Project	<b>IEEE 802.16 Broadband Wireless Access Working Group</b> < <a href="http://ieee802.org/16">http://ieee802.org/16</a> >	
Title	<b>CQICH Based UL Channel Sounding</b>	
Date Submitted	<b>2004-11-04</b>	
Source:	Jianglei Ma, Peiying Zhu, Ming Jia, Dongsheng Yu, Hua Xu, Mo-Han Fong, Hang Zhang, Brian Johnson Nortel Networks 3500 Carling Avenue Ottawa, ON. K2H 8E9 CANADA	Voice: (613)-763-1315 Fax: (613)-765-7723  <a href="mailto:wentong@nortelnetworks.com">wentong@nortelnetworks.com</a>
Re:	Response to Sponsor Ballot call for comment	
Abstract	Combined CQICH and uplink channel sounding	
Purpose	To incorporate the changes here proposed into the 802.16e D6 draft.	
Notice	This document has been prepared to assist IEEE 802.16. It is offered as a basis for discussion and is not binding on the contributing individual(s) or organization(s). The material in this document is subject to change in form and content after further study. The contributor(s) reserve(s) the right to add, amend or withdraw material contained herein.

# CQICH Based UL Channel Sounding

Figure X1

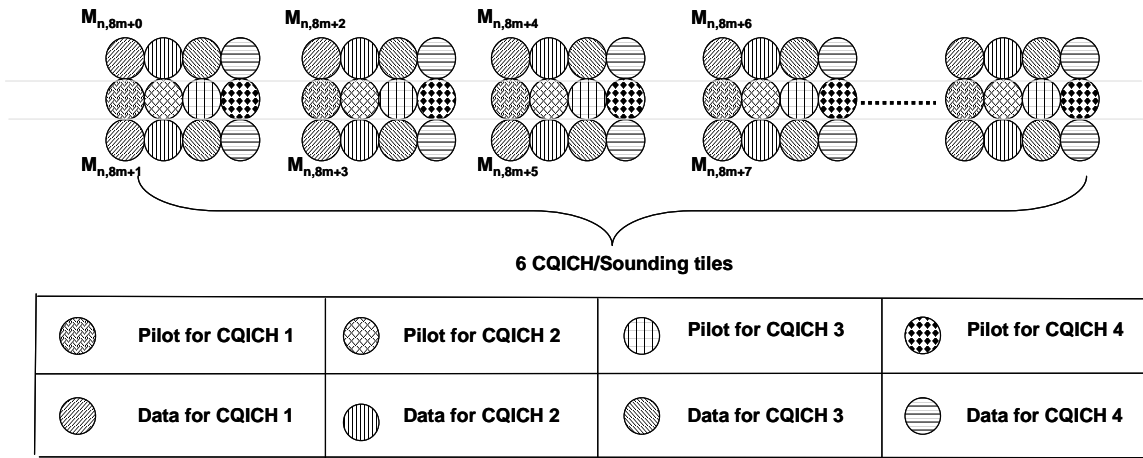
Add the text in Section 8.4.6.2.7.1.

For optional PUSC, to construct the sounding CQICH, each UL tile is partitioned into 3 sub-tiles and each sub-tile consists of one sub-carrier over 3 OFDM symbols. Three sounding CQICH channels are re-mapped by concatenating 4 UL sub-channels. Each sounding CQICH is composed of 24 sub-tiles from 24 tiles. The same modulation scheme defined in section ??? for FAST\_FEEDBACK channels is used. Eight elements in each vector are mapped to 4 sub-tiles, starting from the first sub-tile to the last sub-tile See figure X1 for PUSC and figure X2 for optional PUSC.

Figure X3

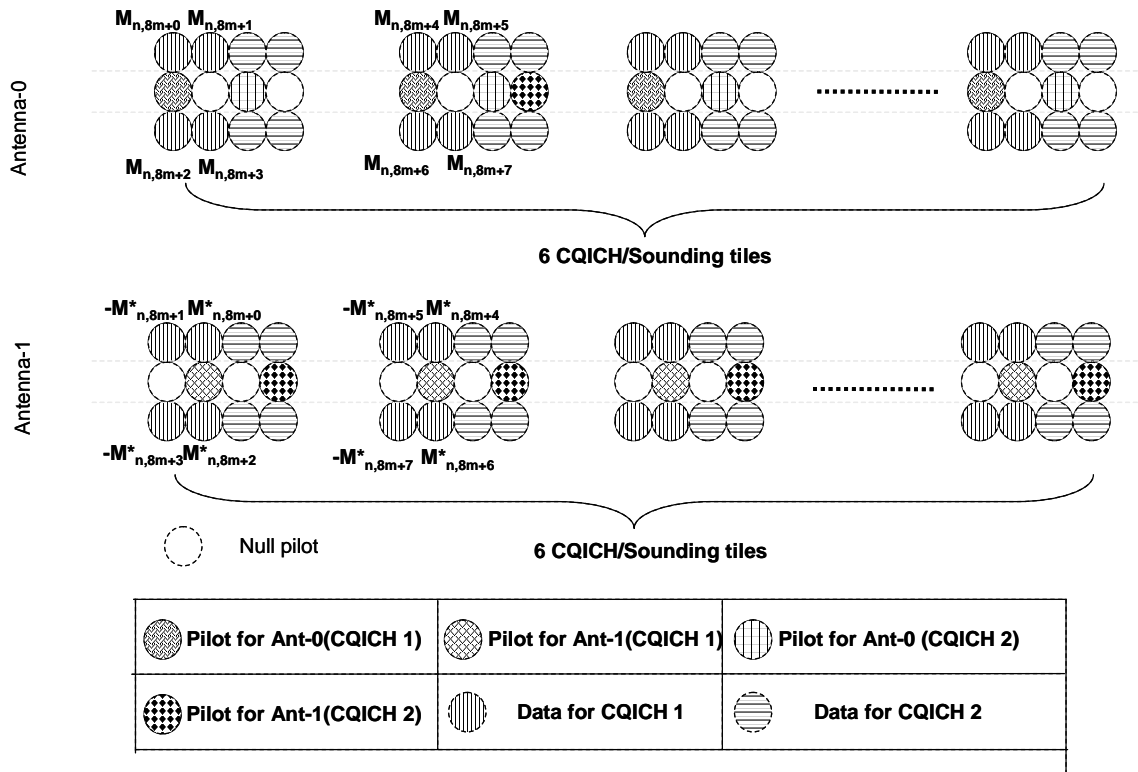
For uplink MIMO capable MSS, STC using 2 antennas can be applied in the transmission of sounding CQICH channel. For PUSC, one MIMO UL sub-channel is constructed from 6 MIMO UL tiles, and each MIMO tile has 4 sub-carriers crossing 3 symbols. To generate MIMO sounding CQICH, each UL tile is re-mapped into 2 sub-tiles and each sub-tile consists of 2 sub-carriers over 3 OFDM symbols. Two MIMO sounding CQICH channels are constructed by concatenating 2 MIMO UL sub-channels. Each MIMO sounding CQICH is composed of 12 sub-tiles from 12 tiles. Two antennas shall use different pilot pattern. Figure X3 shows the construction of MIMO sounding CQICH channel and the data mapping strategy for two antennas.

Figure X4

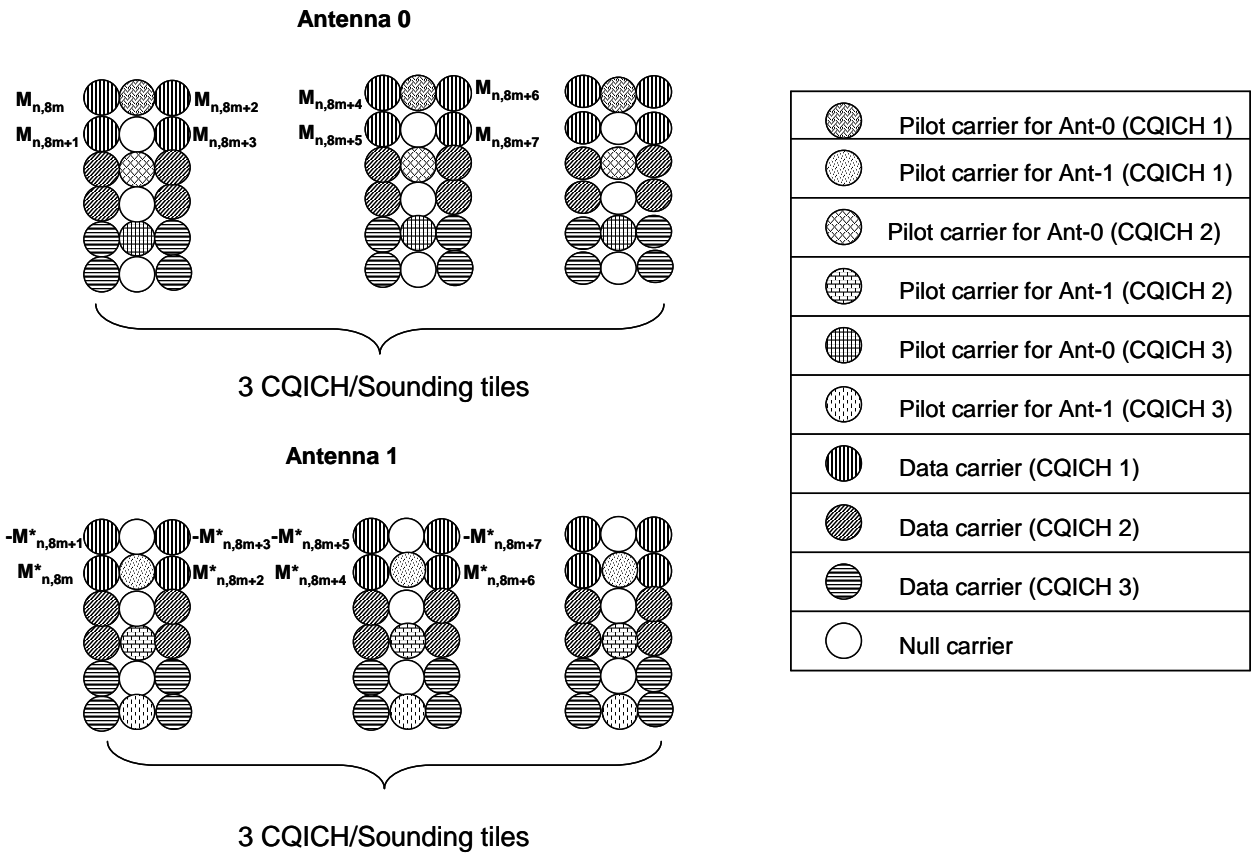
For optional PUSC, one MIMO UL sub-channel is constructed from 3 MIMO UL tiles, and each MIMO tile has 3 sub-carriers crossing 6 symbols. To generate MIMO sounding CQICH, each UL tile is re-mapped into 3 sub-tiles and each sub-tile consists of 3 sub-carriers over 2 OFDM symbols. Three MIMO sounding CQICH channels are constructed by concatenating 4 MIMO UL sub-channels. Each MIMO sounding CQICH is composed of 6 sub-tiles from 6 tiles. Two antennas shall use different pilot pattern. Figure X4 shows the construction of MIMO sounding CQICH channel and the data mapping strategy for two antennas.
